Nebraska Public Power District

NLS2009048

Subject: Response to Request for Additional Information for License Renewal Application
– Severe Accident Mitigation Alternatives
Cooper Nuclear Station, Docket No. 50-298, DPR-46

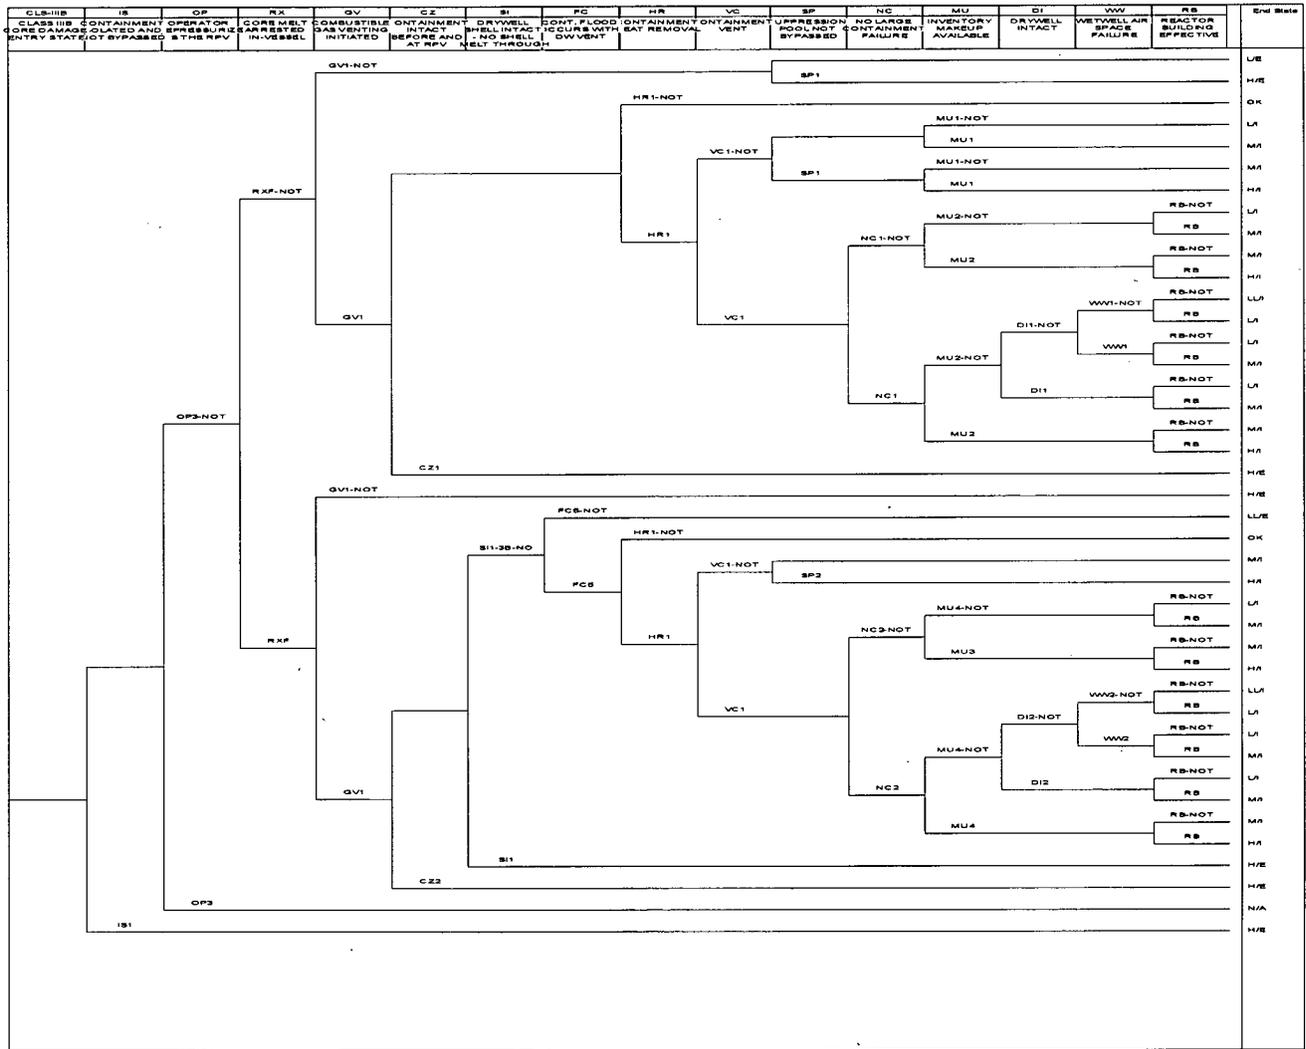
2. Provide the following information relative to the Level 2 analysis:
- a. Table E.1-10 identifies the release fractions for each release mode. The release fractions for iodine and cesium for the LL/I release mode are significantly lower than the corresponding release fractions for both the LL/E and LL/L release modes. Provide an explanation for this apparent anomaly.

- 2.a. As described in ER Section E.1.2.2.6, for each CET sequence, a value for each of the release-to-environment mass fractions was obtained from the representative MAAP calculation. These mass fractions were then weighted according to the contribution of that sequence to the sum of the sequences in the end state bin. The final mass fraction representing the end state bin was the sum of these individual weighted mass fractions for each species. An example of this calculation is provided in the response to Question 2b.

For the LL/I end state, the dominant sequences involve offsite release via containment venting through an intact suppression pool. This path results in very effective fission product scrubbing resulting in very low offsite releases. The MAAP run representing the

dominant sequences for the LL/I end state has a cesium iodide (CsI) release fraction of $1.79\text{E-}6$.
